Your Ref:
Our Ref: LTR004-01-20-748-Westlink Stage 1
Earthworks Letter

RE: WESTLINK INDUSTRIAL DEVELOPMENT STAGE 1, KEMPS CREEK BULK EARTHWORKS

Figure 1 Typical Section along Northern Boundary (Stage 1)

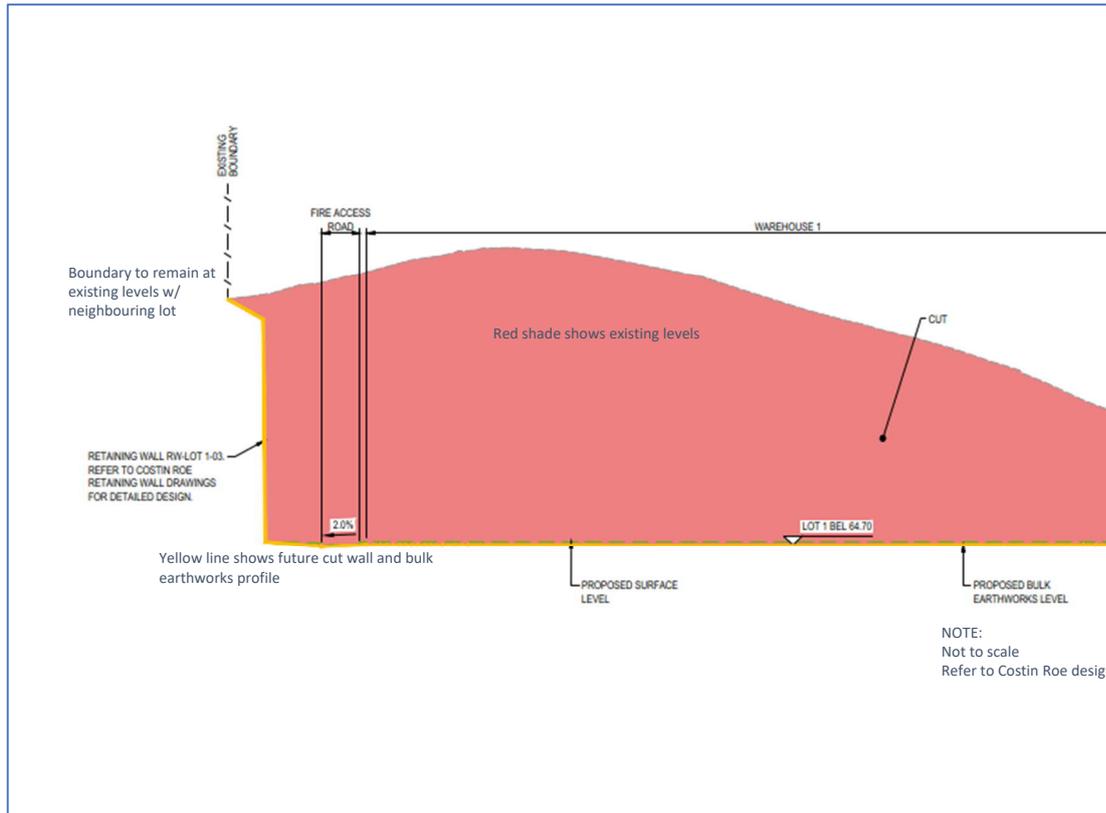
- Is there a requirement for any works within any adjoining properties not owned by ESR, including earthworks, battering or anchors;
- Whether the earthworks and proposed levels will result in any impediment or additional cost for future development on adjoining properties, such as inability to develop up to the property boundary. This includes, but not limited to consideration of zones of influence, need for footings and piers or increased levels of earthworks on adjoining sites.
- The maximum height of cut retaining walls along the northern boundary.

- Is there a requirement for any works within any adjoining properties not owned by ESR, including earthworks, battering or anchors – **ATL Response – can confirm no requirement for earthworks and/or battering within adjoining lands. All boundary levels around the site will be maintained with earthworks only required within the ESR development site. Refer to attached typical section along Northern Boundary which indicates the existing boundary level is maintained and no works required in the adjoining properties.**
